Re: Response to EnviroAssets, Inc. (EAI) Comments on The Supplemental Remedial Investigation Report for Former Red Hanger Kleaners, 6235-6239 College Ave., Oakland, CA RO00002981

**SOIL VAPOR AND GROUNDWATER MONITORING LOCATIONS**

**FORMER RED HANGER KLEANERS OAKLAND, CALIFORNIA**

Figure:  
1

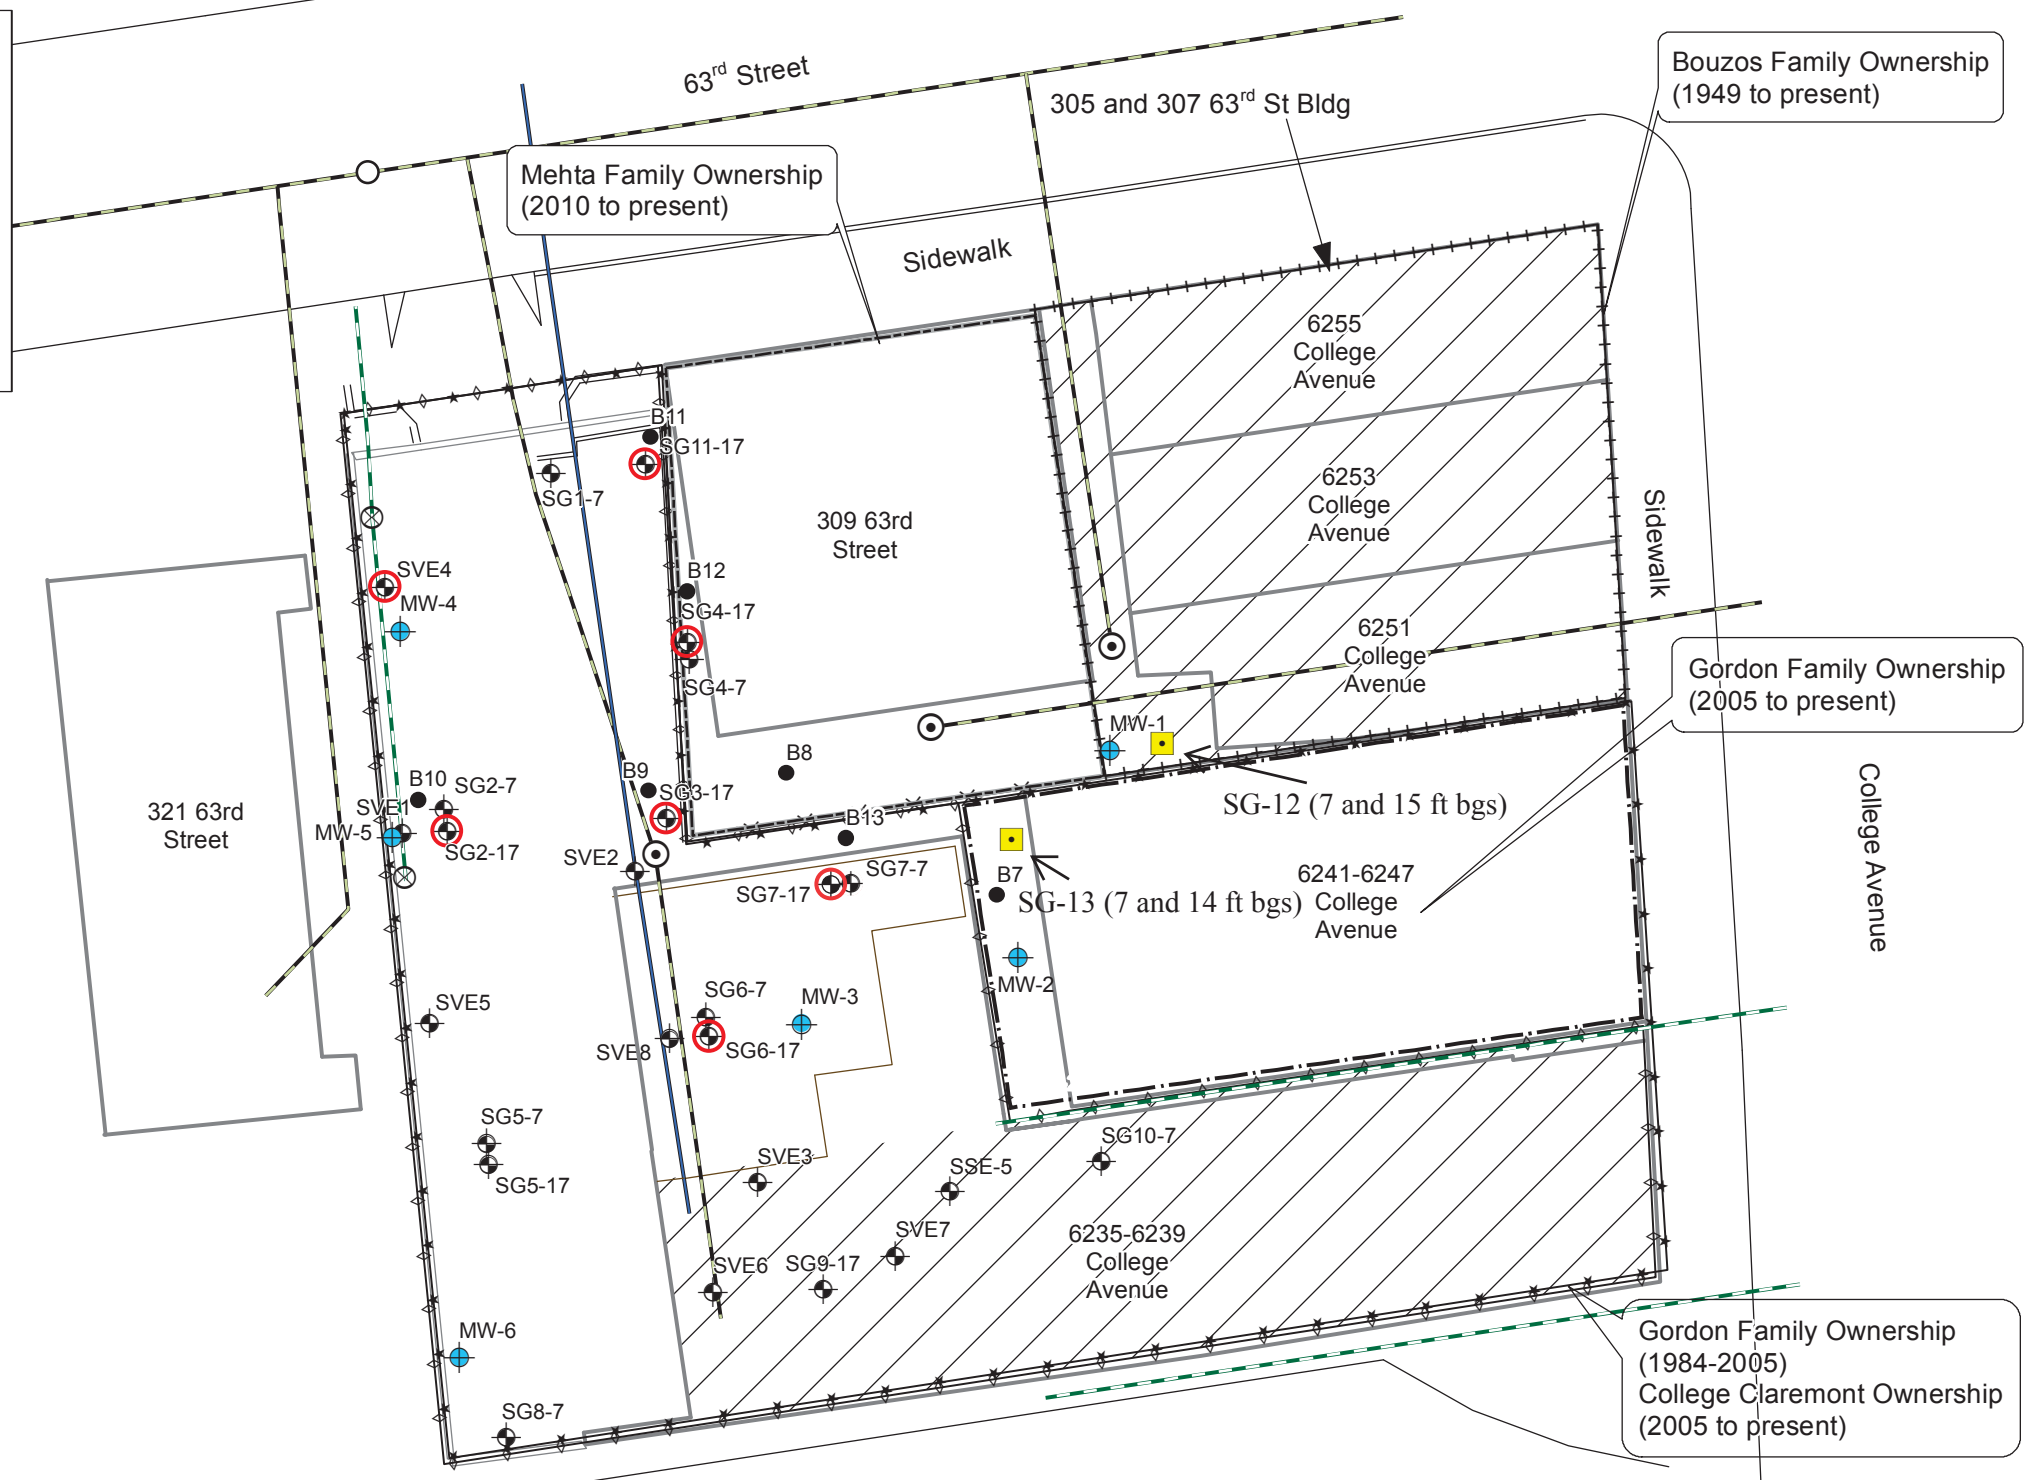
- Groundwater monitoring well MW-1 is located on the southwestern corner of the 6251-6255 College Ave., property (see Figure 1). Based on available groundwater elevation data from this well and the remaining five monitoring wells located on the immediately adjacent properties (see Figure 1), at a minimum, the southwestern corner of the 6251-6255 College Ave. property is located hydraulically upgradient of the CCV site, and the property located at 6241-6247 College Ave. As such, MW-1 serves as the upgradient well for the CCV property, indicative of groundwater quality at locations immediately upgradient of the CCV site.

- The presence of PCE in the groundwater sample at MW-1, and its concurrent absence (above detection limits) from the closest downgradient wells on both the CCV site and the 6241-6247 College Ave sites (i.e, MW-2 located less than 20 feet away from MW-1 and on the 6241-6247 College Ave. property, and MW-3 located approximately 50 feet away from MW-1 and on the CCV site) indicate that based on available data, PCE-impacted groundwater exists hydraulically upgradient of the CCV property. These data also suggest that a release of PCE to the subsurface may have occurred at a location hydraulically upgradient of the CCV property. It should also be noted that the presence of PCE in the deep (i.e, 15 feet bgs) soil vapor sample collected immediately adjacent to MW-1 (i.e, at SG-12-15) and on the 6251-6255 College Ave., property, further supports the potential for a subsurface release of PCE upgradient of the CCV site.<sup>2</sup>

- As previously indicated, the 6251-6255 College Ave., is located less than 20 feet northeast (and hydraulically upgradient) of the CCV site. Based on publicly available information, the 6251-6255 College Ave., property was reportedly used for dry cleaning operations from 1938 to the 1985/1986 time frame, wherein PCE was a commonly used cleaning solvent. Moreover, available County records (which do not cover time periods older than 1986/1987) reportedly suggest inappropriate storage of drums containing waste “PERC” materials occurred at the 6251-6255 College Ave., property prior to 1987; this information further supports the potential for dry cleaning operations at the 6251-6255 College Ave. property to have caused a release of PCE to the subsurface. Worth noting is that Fugro (2017)<sup>3</sup> includes an independent evaluation of other existing information, including a review of city records, a survey of sewer lines, and review of permit and site usage records, all of which contributed to a similar conclusion by Fugro regarding the potential for an independent release of PCE to the subsurface at the 6251-6255 College Ave. property.
